**REPAIR AND PREVENTATIVE MAINTENANCE
OF THE
HAMILTON AVENUE SCHOOL
PARKING GARAGE**
Greenwich, Connecticut
BID NO. 2529-25

ADDENDUM NO. 3

Date: April 23, 2025

NEW CONCRETE SIDEWALK
TYPICAL SECTIONS

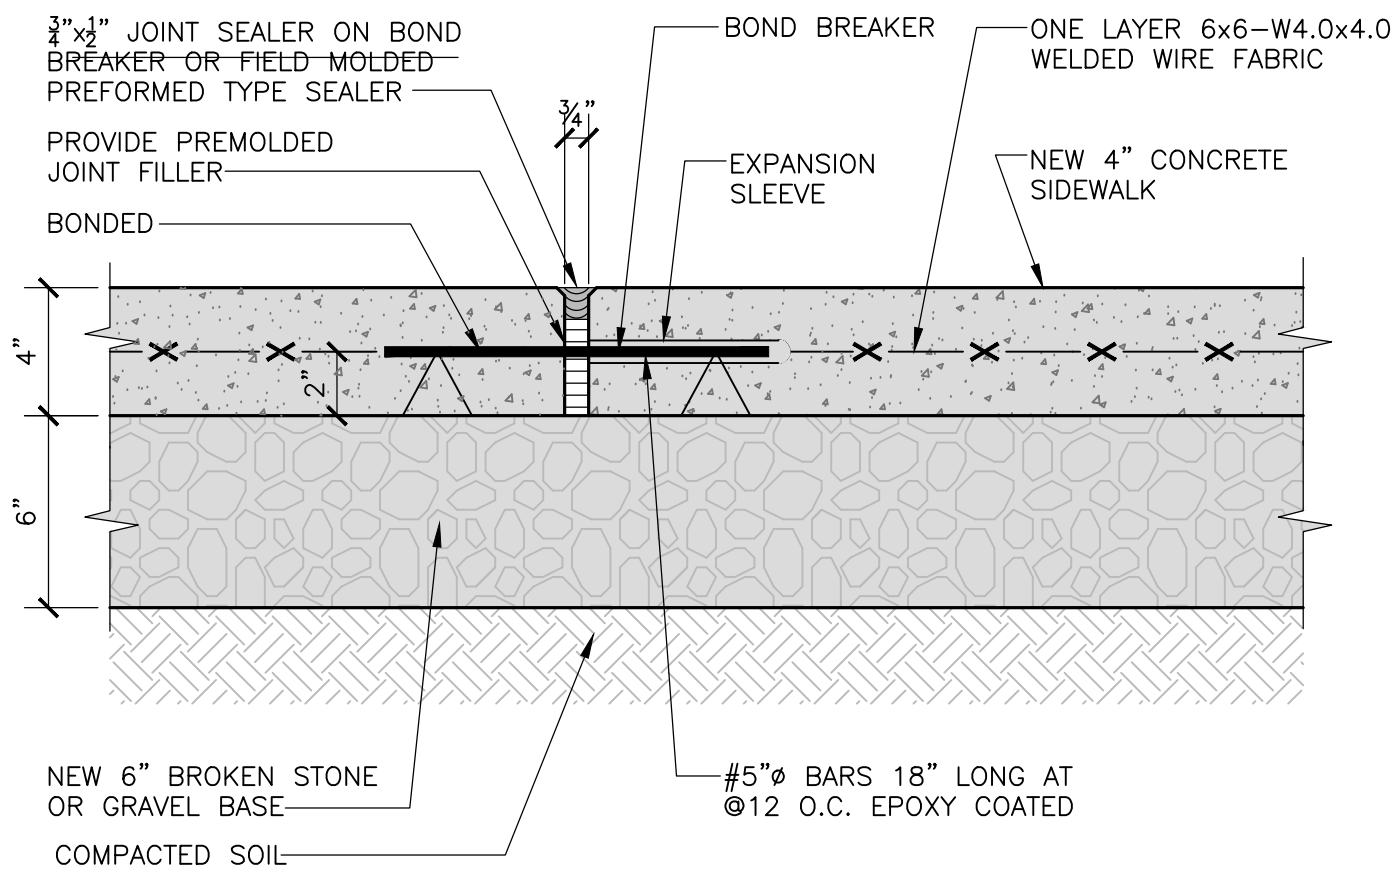
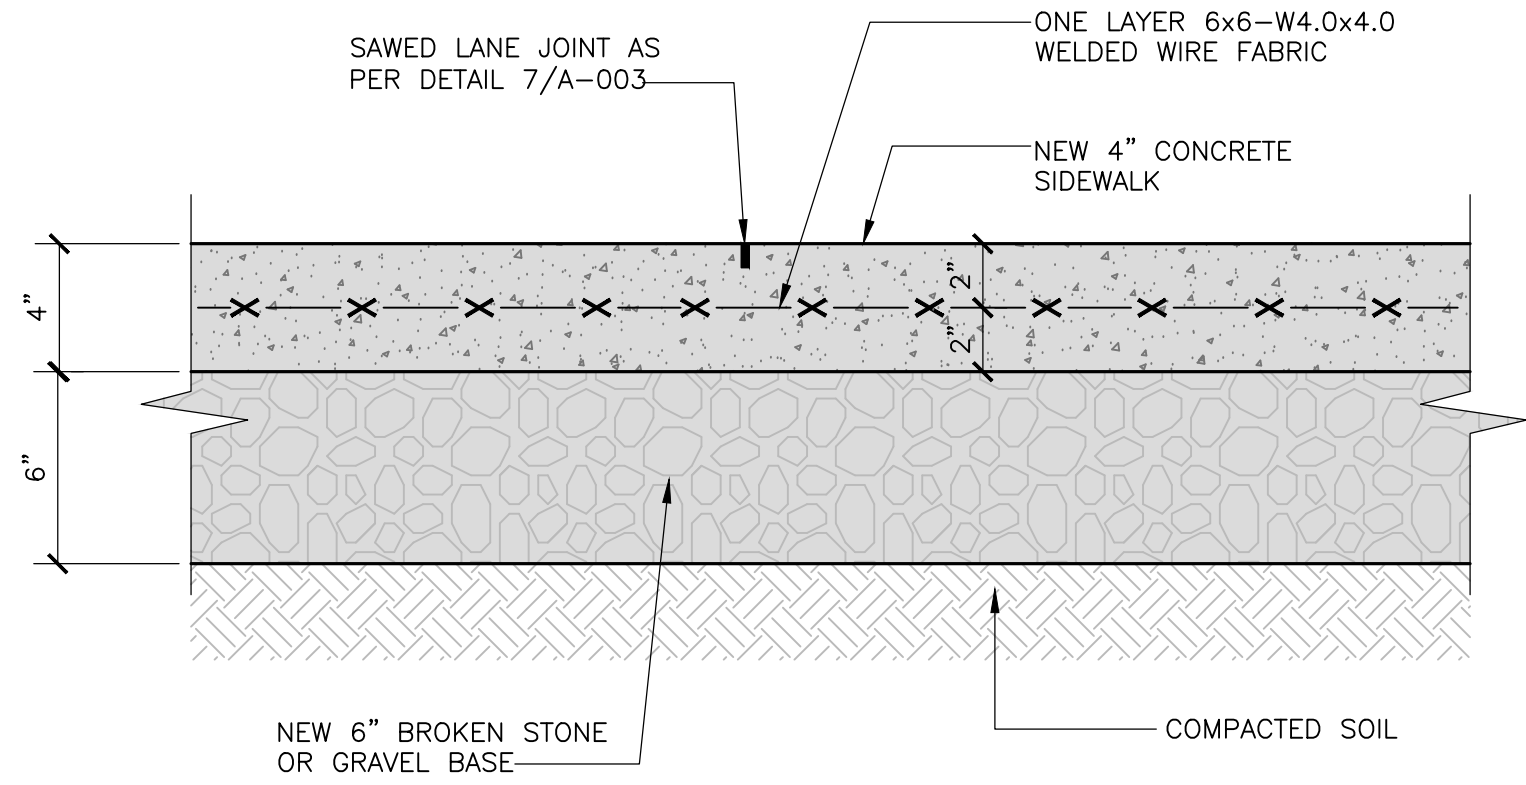
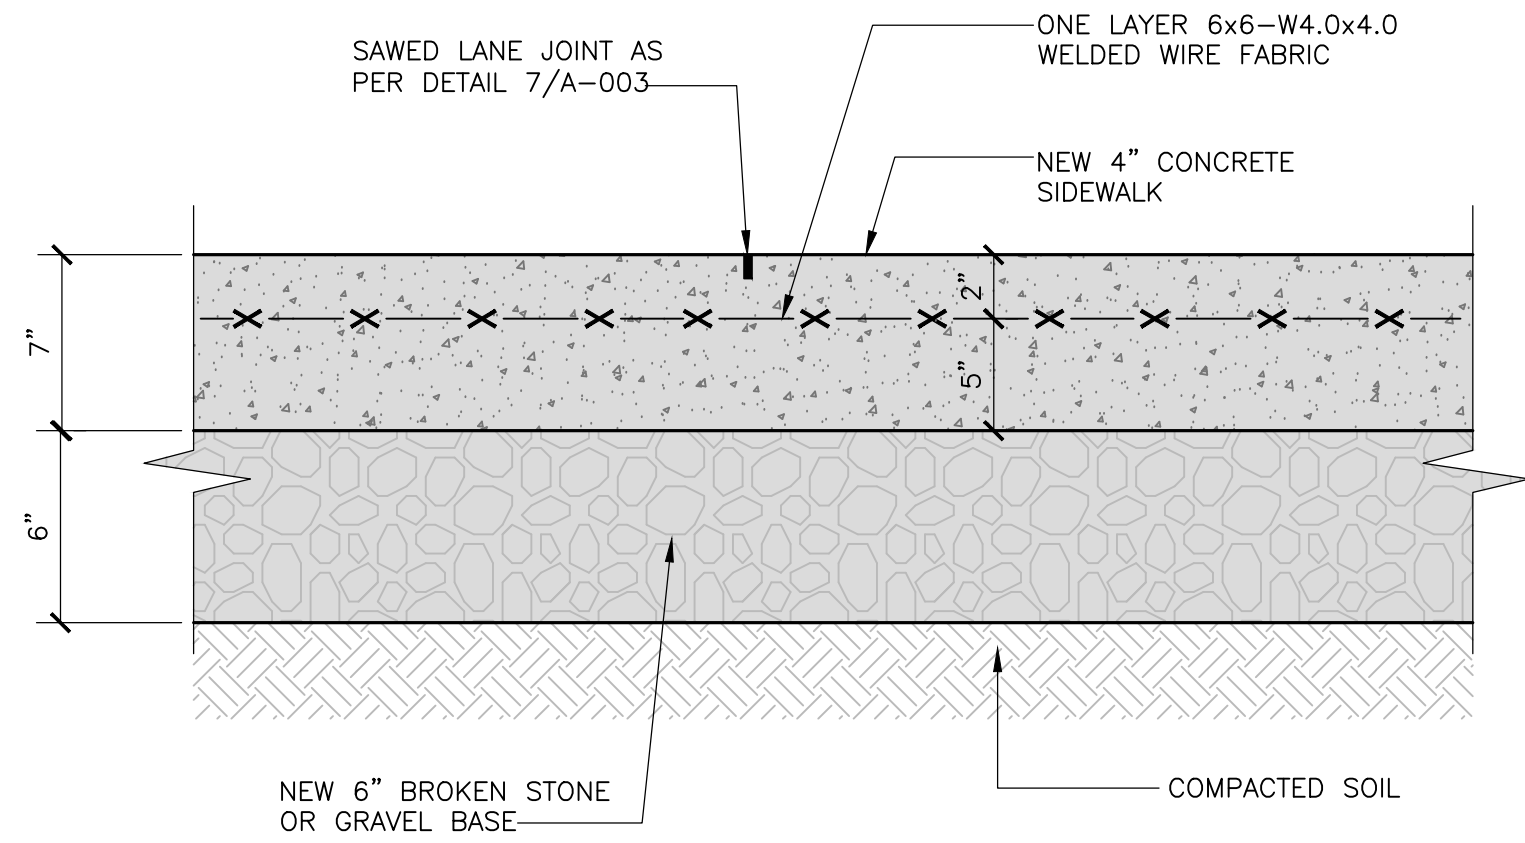
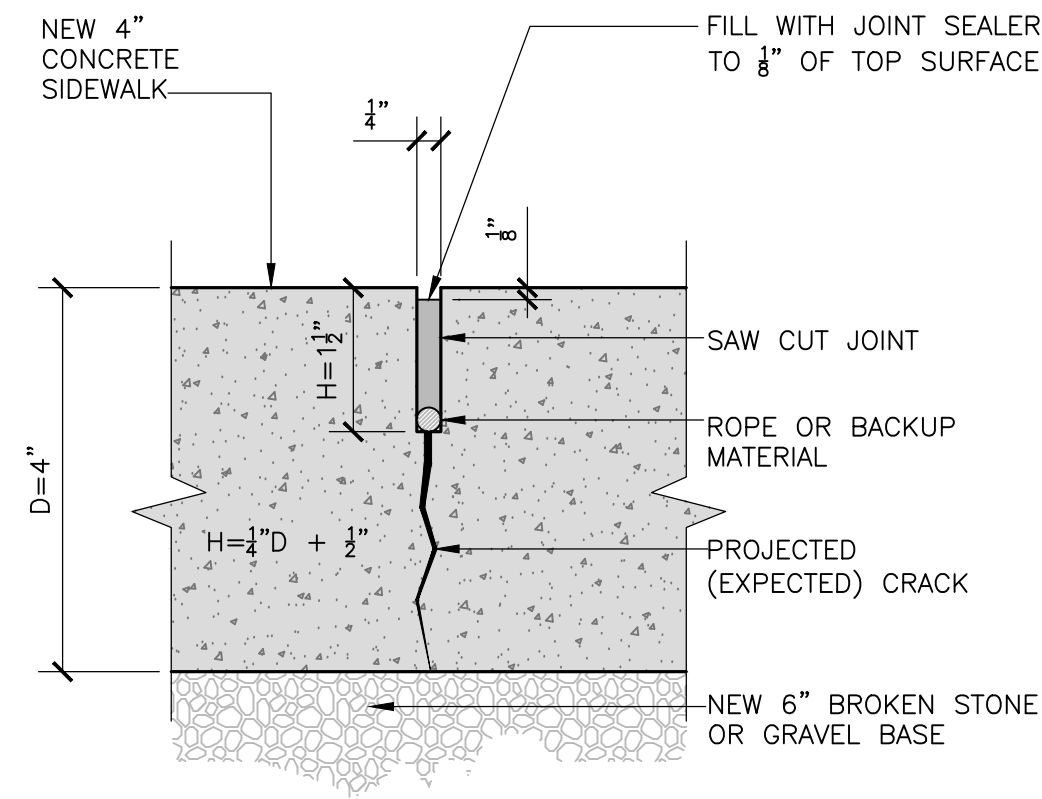
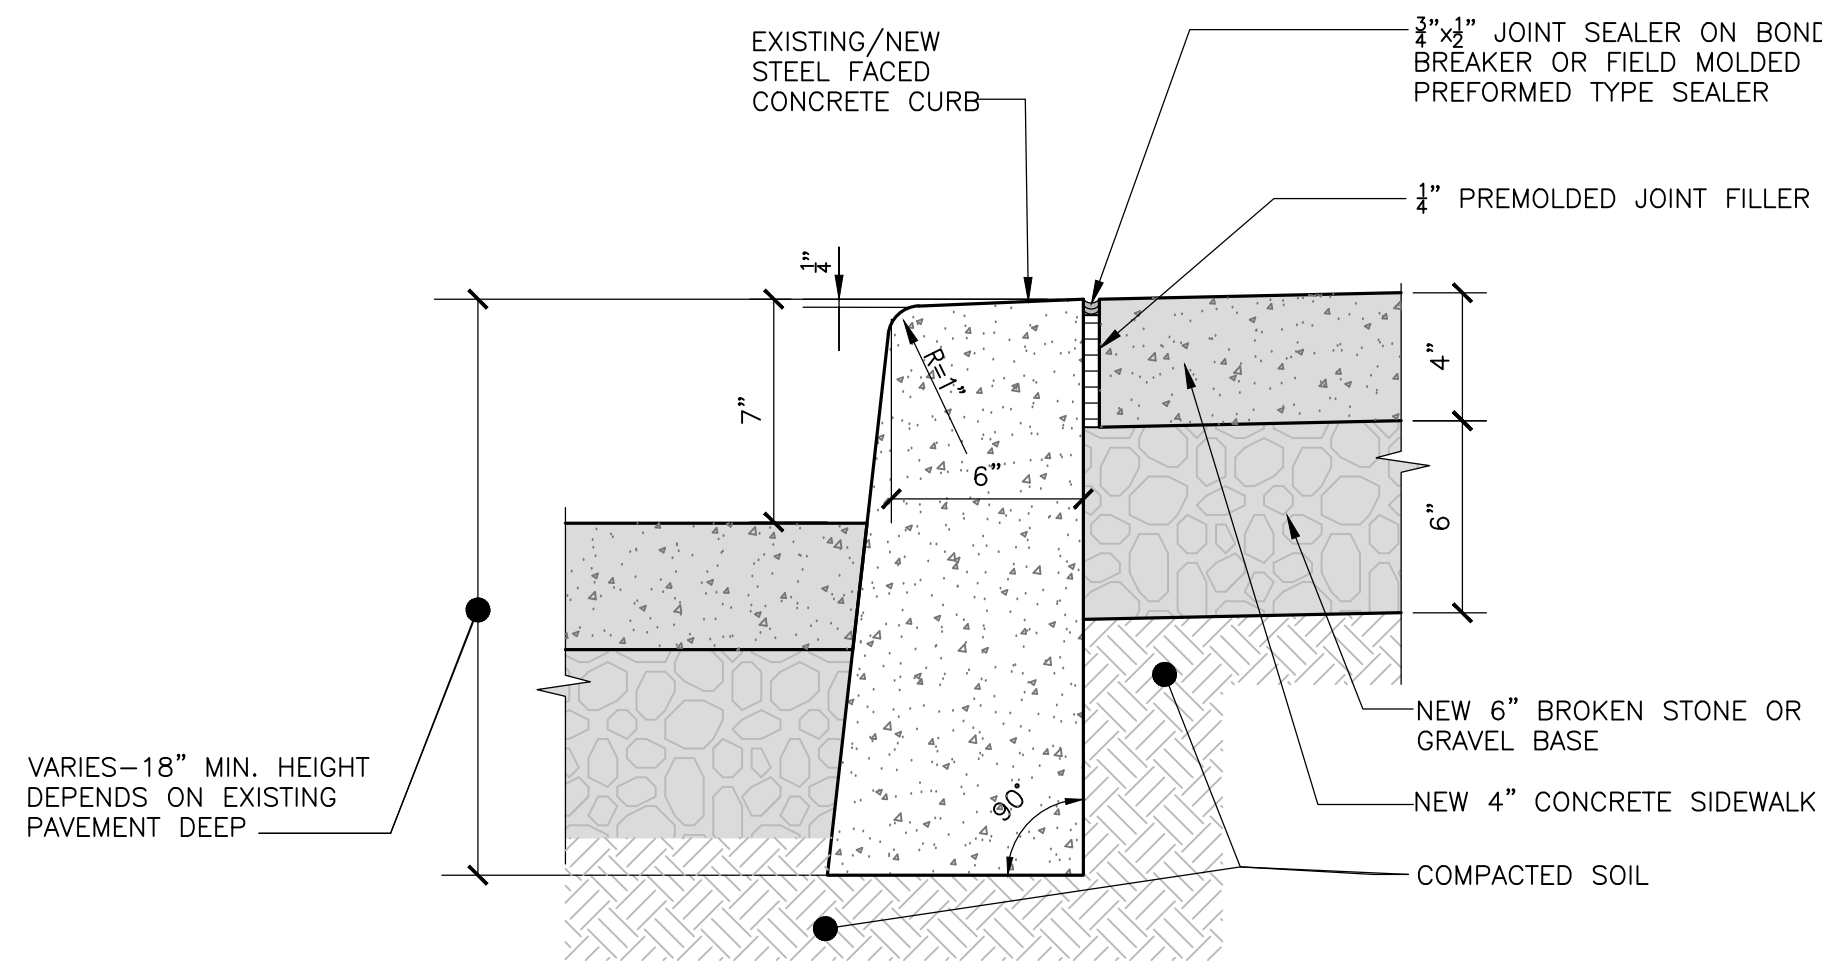
- Please clarify if this sidewalk (1,700 SF) corresponds to the areas of sidewalks along the North & East sides of the garage which are scheduled to be replaced as per dwgs DM-01, A-01, A-01A but have not line item in phase 2.
- Please provide a detail for the new concrete curb (120 LF) to be included in this line item as per alternate's description, showing properly its dimensions & materials to be used.

The sidewalk replacement is now included in Phase 1 of the Base Bid. See revised Addendum No. 2A Bid Form for clarifications. Typical concrete curb detail included on revised Addendum No. 2A Drawings
